Reference	SSM72516
Models	XF / X260
Title	X260 XF Boot spring bracket detaching
Category	Body
Last modified	23-Nov-2015 00:00:00
Symptom	111000 Body Panel(s)/Unibody
Attachments	BIW Spring bracket SSM 2 (1).pdf (BIW Spring bracket SSM 2 (1).pdf)

X260 Boot spring detaching from Body In White bracket and / or spigot bracket

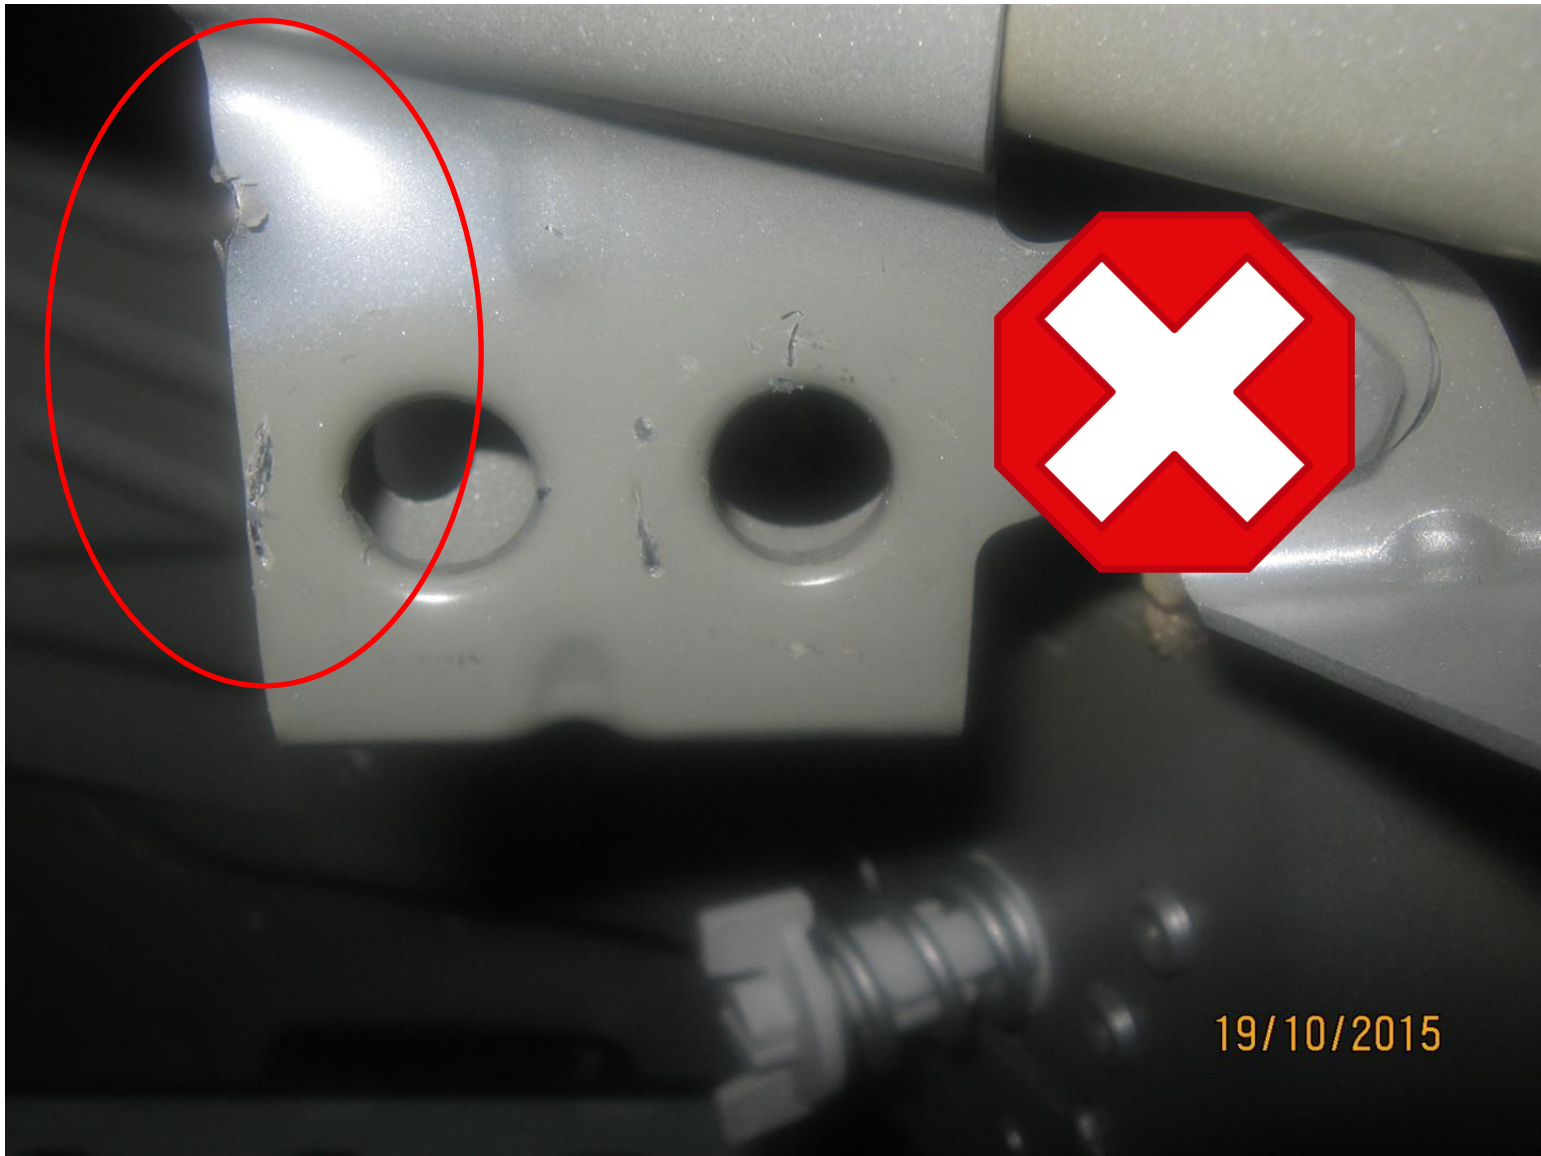
Tolerance between fulcrum points on components

If you have a X260 where the boot spring has detached, please order replacement assistance springs and spigot / ball fixing brackets located on the swan neck assemblies and replace both sides regardless of which has failed.

In addition, please check the integrity and condition of the Body In White bracket on both sides for any damage and re-work / rectify to bring them to the acceptable condition, particularly the profiling and alignment, as shown on the attachment - before installing new components.
